Access Compliance Report

Public Rights-of-Way

(Curb Ramps)

Intersection ID: N/A	Main Street: RIDGEMORE_DR	Cross Street: OAK_GLEN_LN	Location: NE
ADA ID: 4FA7862C79FD	Ramp Type: PerpDiag	Initial Pass/Fail: Fail	Overall Compliance: No
		Severity Score: 25

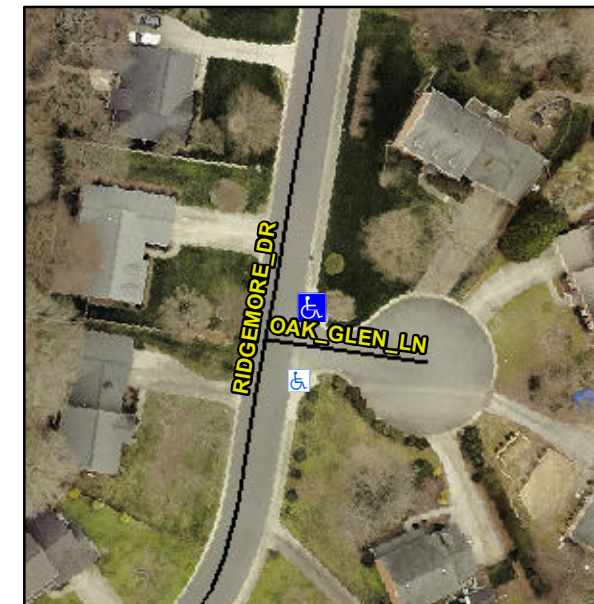
Not Found, R304.5.3

Compliance	Description	Data	Compliance	Description	Data
N/A	Ramp Length (in)	55.0	Yes	Ramp Slope (%)	6.8
Yes	Ramp Width (in)	48.0	No	Ramp XSlope (%)	9.8
N/A	Flare Type LT	N/A	N/A	Flare Type RT	N/A
N/A	Flare Slope LT (%)	N/A	N/A	Flare Slope RT (%)	N/A
N/A	Flare Traversable LT?	N/A	N/A	Flare Traversable RT?	N/A
N/A	Landing Length (in)	N/A	N/A	DWS Provided?	N/A
N/A	Landing Width (in)	N/A	N/A	DWS Contrast?	N/A
N/A	Landing Slope (%)	N/A	N/A	DWS Length (in)	N/A
N/A	Landing X Slope (%)	N/A	N/A	DWS Full Width?	N/A
N/A	Landing Curb? (Y/N)	N/A	N/A	DWS Offset (in)	N/A
N/A	Shared Landing?	N/A			
N/A	Gutter Ponding?	N/A	N/A	Gutter Slope (%)	N/A
N/A	Gutter Lip Ht (in)	N/A	N/A	Gutter X Slope (%)	N/A
N/A	Painted X Walk1?	No	N/A	Painted X Walk2?	No
	X Walk 1 Direction	To W		X Walk 2 Direction	To S
N/A	X Walk 1 Width (in)	N/A	N/A	X Walk 2 Width (in)	N/A
	X Walk 1 Slope (%)	1.3		X Walk 2 Slope (%)	3.2
	X Walk 1 X Slope (%)	3.4		X Walk 2 X Slope (%)	7.3

Remove & Replace Curb Ramp With Two New Directional Ramps or Equivalent.
